PROPOSED TECHNICAL SPECIFICATION CHANGES

Power Authority of the
State of New York
May 1, 1978

ERRATA TO SAFETY EVALUATION

Figure 3.10-2 Hot Channel Factor Normalized Operating Envelope.

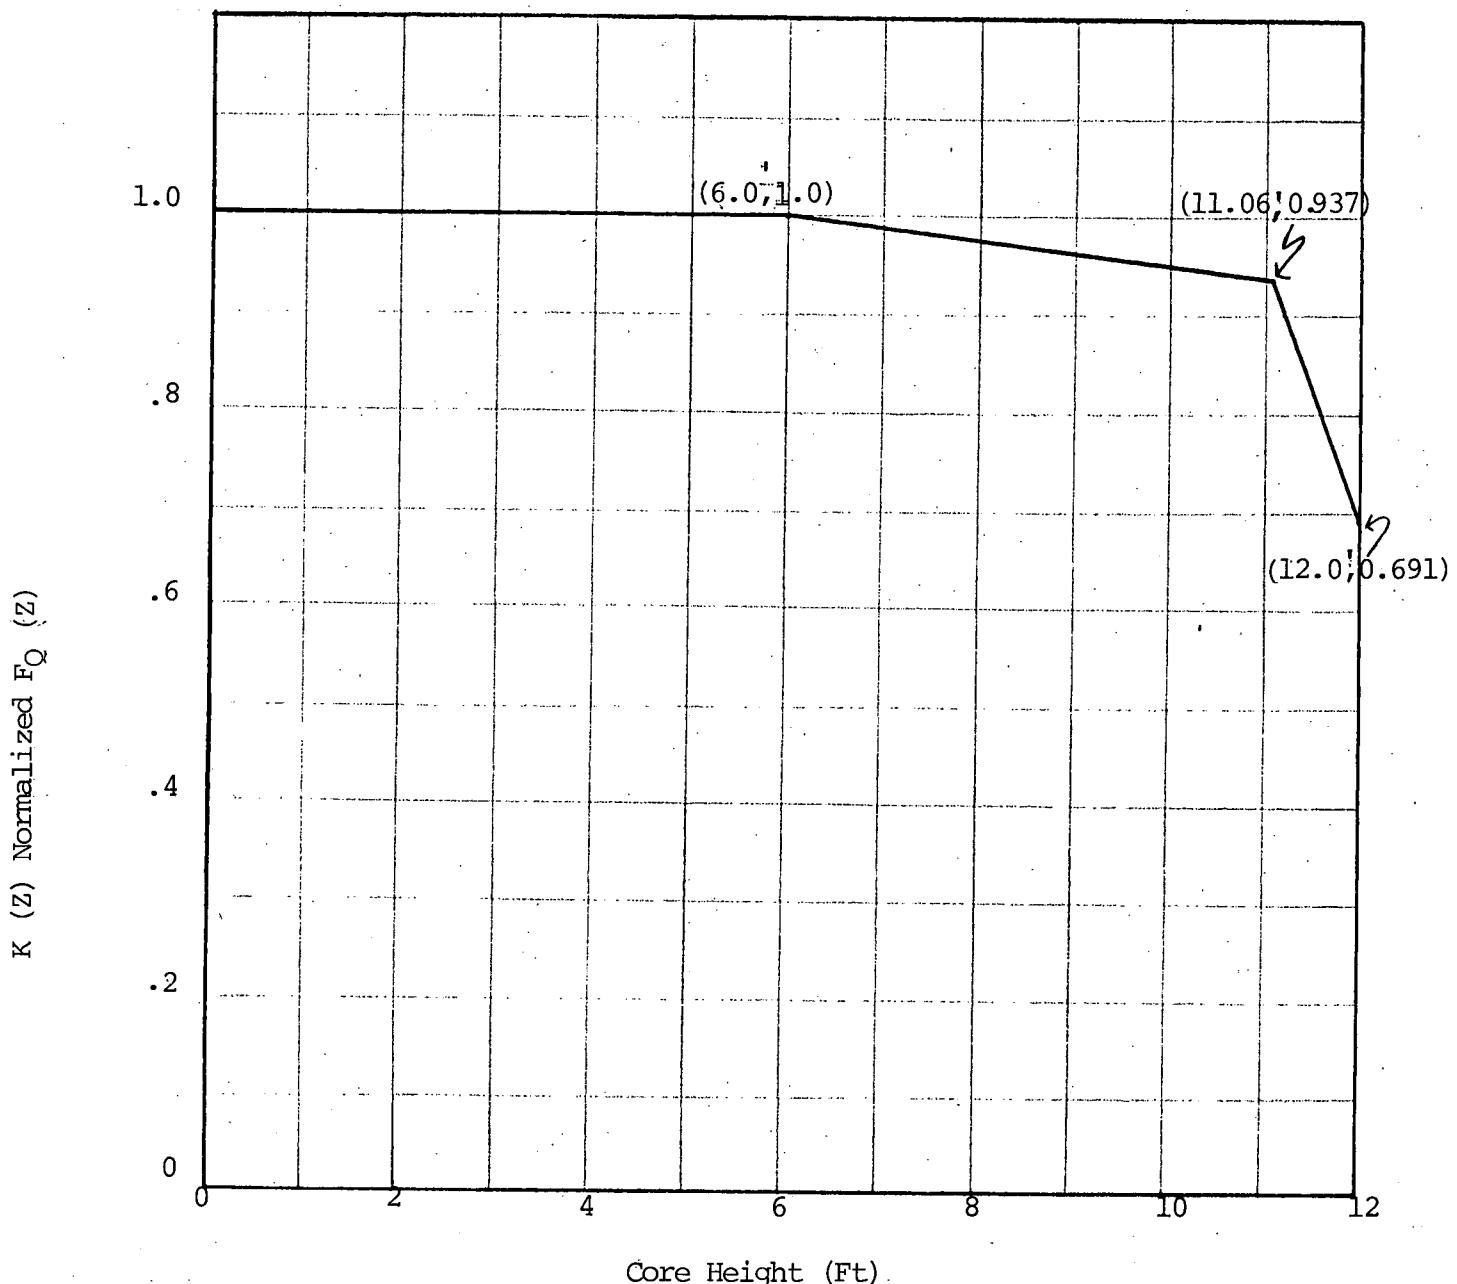
$$F_Q(Z) \leq (2.17/P) \times K(Z) \text{ for } P > 0.5$$

$$F_Q(Z) \leq (4.84) \times K(Z) \text{ for } P \leq 0.5$$

$K(Z)$ is the fraction given in Figure 3.10-2 and Z is the core height location of F_Q .

An upper bound envelope of 2.17 times the normalized peaking factor axial dependence of Figure 3.10-2 has been determined consistent with Appendix K criteria and is satisfied by all operating maneuvers consistent with the technical specifications on power distribution control as given in Section 3.10. The results of the loss of coolant accident analyses based on this upper bound normalized envelope of Figure 3.10-2 demonstrate a peak clad temperature below the 2200°F limit.²

Hot Channel Factor Normalized
Operating Envelope

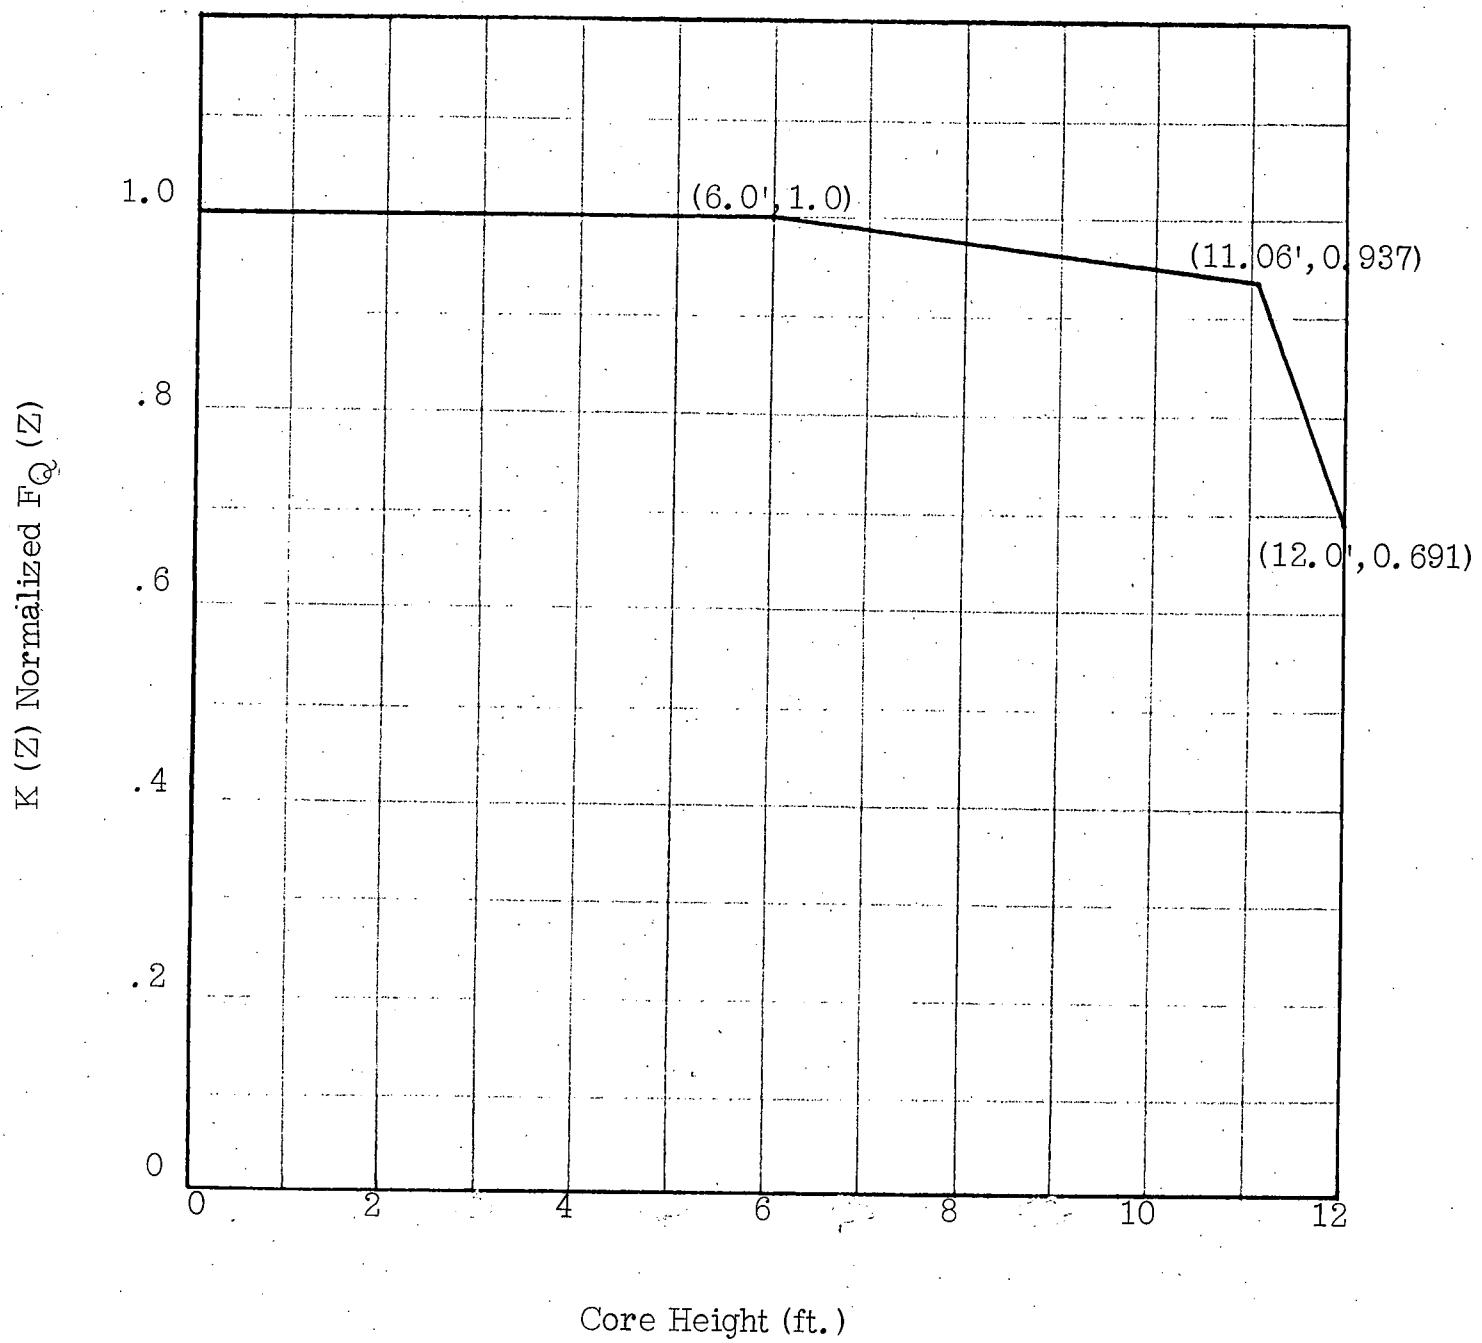
1. Page 3, paragraph 1, line 4, change from "...limit of \leq 2.32 x K(Z)..." to "...limit of \leq 2.17 x K (Z)..."
2. Page 5, Section 3.1 line 8, change from "... below 2.32 x K(Z)..." to "...below 2.17 x K(Z)..."
3. Page 10, Section 4.1, paragraph 2, line 2, change from "... to (12.0,0.647)..." to "...to (12.0,0.691)..."
4. Page 10. Section 4.1, paragraph 3, line 2, change from "... less than + 12.5% at ..." to "... less than +10.0% at ..."
5. Insert attached Figure 2-Hot Channel Factor Normalized Operating Envelope.
6. Insert attached Figure 3-Full Length Rod Insertion Limit 100 Step Overlap Four Loop Operation.
